Statement of Response to An Bord Pleanála Opinion

Proposed Strategic Housing Development at Bridgegate, Rathgory & Mulladrillen, Ardee, Co. Louth

John Spain Associates

March 2022

Figure 2.1: Extract of Phasing Plan (DA Drawing no. PA-003)

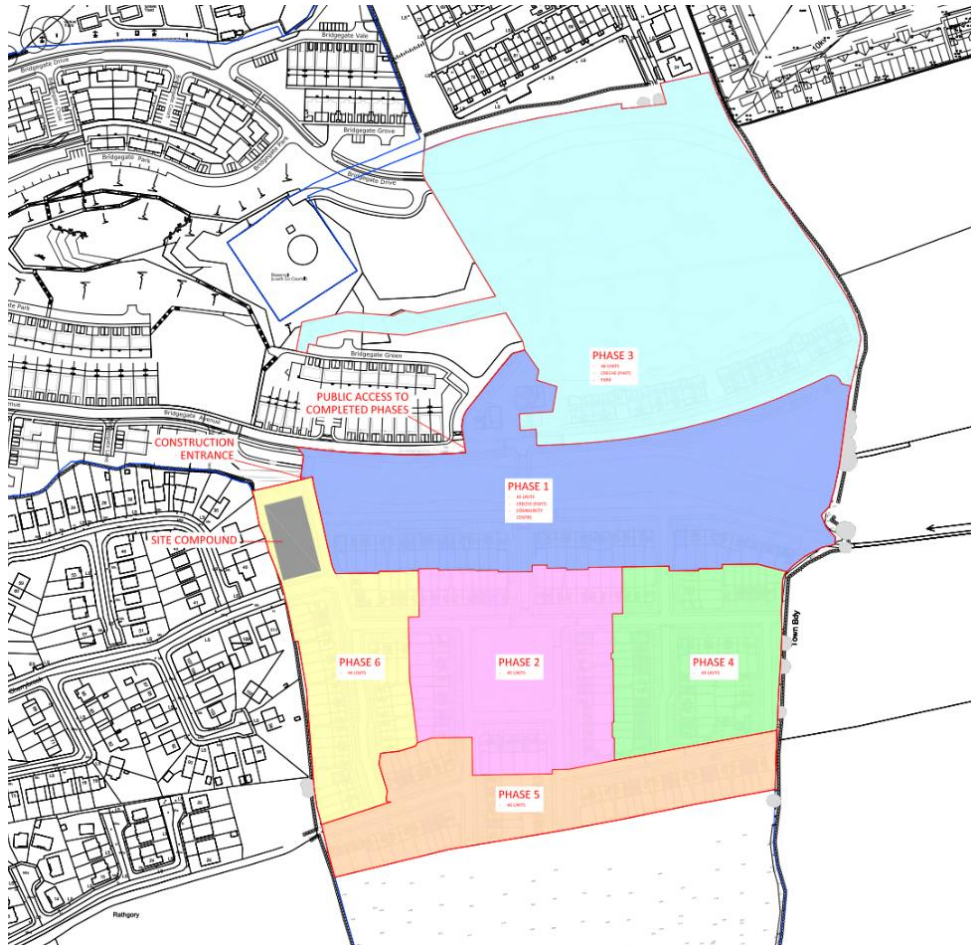
5. A phasing plan for the proposed development which includes the phasing arrangements for the delivery of the public open spaces and Part V provision.

- 2.5 Following pre-application with Louth County Council and An Bord Pleanála, the applicant now seeks a 7-year planning permission for the proposed development.
- 2.6 The applicant is currently on site at Phases 1-3 of Bridgegate (Reg. Ref.: 10174; ABP Ref: PL15.238053), with Phase 1 complete and works started on Phase 2. The permission was extended under Reg. Ref.: 21135 and expires on 4th March 2027 however, works are anticipated to be completed well in advance of this date. Planning permission Reg. Ref.: 19336 and Reg. Ref.: 19353 for Phase 2 and 3 of the development was extended by LCC to 31st December 2025, with works currently undergoing. The proposed indicative completion rates for the permitted development northwest of the subject site are shown below, as provided by The Ardee Partnership.

- 2.7 As noted, Phase 1 is now complete, and Phase 2 is now under construction. Phase 3 is anticipated to begin mid-2023. These are indicative build-out rates and the construction programmes have been developed following understanding of the previous stages and the sales velocity experienced at the location.
- 2.8 The applicant is committed to the build out the overall development within 7 years of a grant of planning permission of the application now submitted at Phase 4. The phased implementation of the development is considered to be acceptable to the Planning Authority as set out in their Pre-Application Opinion dated October 2020. The proposed development will be constructed across 6 phases, shown in the extract of submitted Darmody Architecture (DA) Drawing PA-003 in the context of the wider development at Bridgegate.

Figure 2.2: Potential Connections to Lands to the East

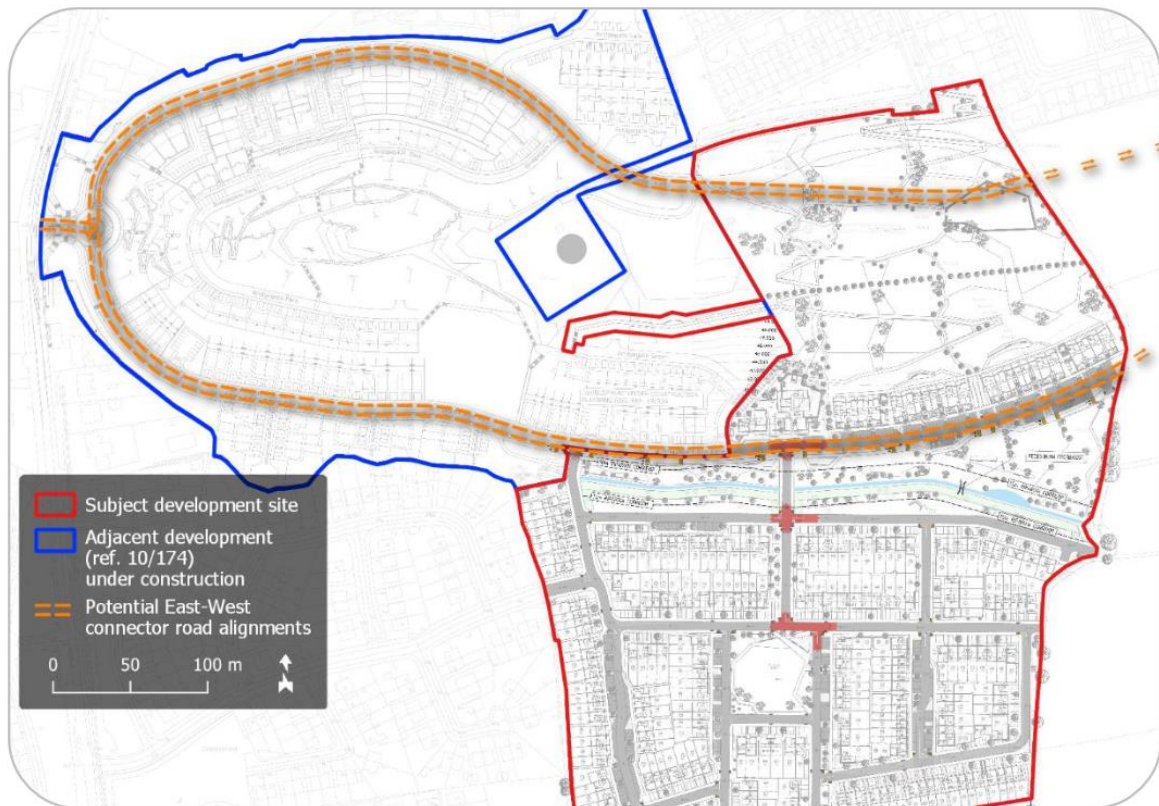
- 4. Further consideration / amendment of the location of the link road as required by Objective INF13, having regard to the development potential of lands to the east of the site, which are zoned as Strategic Reserve and to the zoning objective of the northern portion of the site which seeks to provide a '12 acre' area of open space.**

- 2.25 Therefore, the proposed development is demonstrated to facilitate a future link between Rathgory & Mulladrillen and Black Road. The potential routes are shown below in Figure 2.2.

- 2.26 The proposed extension of Bridgegate Avenue to the eastern boundary has been designed to form future connector road and in accordance with DMURS and is considered to represent the most appropriate and efficient route through the lands. A potential indicative road route has also been illustrated through the northernmost section of the public park area. Please refer to SDA drawing no. 20-547-SDA-PD-DR-001 for details.
